- 2. Kasilof Alaska Subdivision 2023 Replat
KPB File 2023-147
Johnson Surveying / Hallstead, Coyle
Location: Old Setnetter Dr. off Kalifornsky Beach Rd.
Kalifornsky Area**

**ITEM #2 - PRELIMINARY PLAT
KASILOF ALASKA SUBDIVISION 2023 REPLAT**

KPB File No.	2023.147
Plat Committee Meeting:	February 26, 2024
Applicant / Owner:	David Harry Hallstead of Kasilof & Darlene Coyle of Kasilof
Surveyor:	Jerry Johnson / Johnson Surveying
General Location:	Kalifornsky Beach / Kalifornsky APC

Kasilof, Alaska Subd. 2023 Replat Preliminary Plat

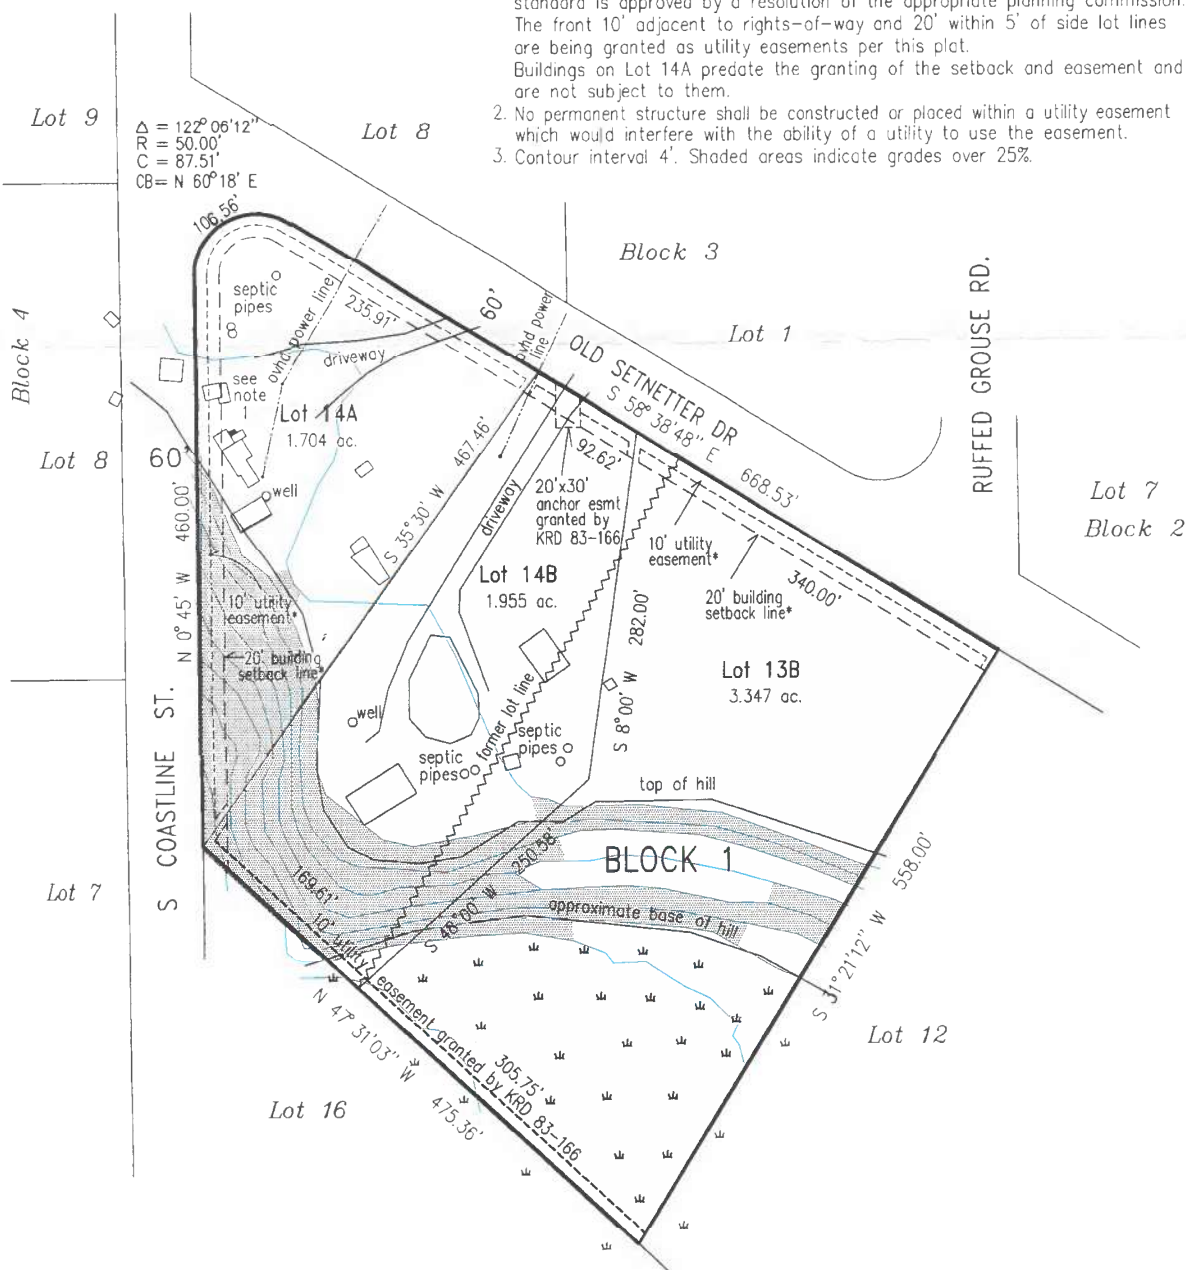
There are buildings in the 20' building setback and 10' utility easement on proposed lot 14A that predate the setback and utility easement and are therefore exempt from them as they exist now. **Staff recommends:** a sentence be added to plat note 1 to the effect as follows: any additions to the structures or new structures shall comply to the limits of the 20' setback.

There is shown a structure in the right-of-way of Coastline St S and two structures across Coastline St S in the property to the west. A solution to these encroachments needs to be submitted to staff with the first submittal of the final plat and followed through with to gain approval of the final mylar. An as-built will need submitted at that time prior to final approval. **Staff recommends:** the Committee concur these issues need resolved prior to final approval.

There are steep areas shown on the plat by the contours and shaded where greater than 20 percent. The top of hill and base of hill are labeled also. The labels and shading should remain for the final plat and the contours can be removed. Structures that do not encroach on an easement or property line should also be removed.

- Add Darlene Coyle as an owner in title block.
- Change the PO Box number for Donald H Hallstead to 1004
- Add KPB no 2023-147 to title block
- Add "Amended" to the plat name after Subd. In the legal.

Street name on the west should be Coastline St S

- Add street and names to get to the site and adjacent to.

- Add Block 1 to the lots south and west.
- Change Lot 16 to 15 on the lot to the southwest
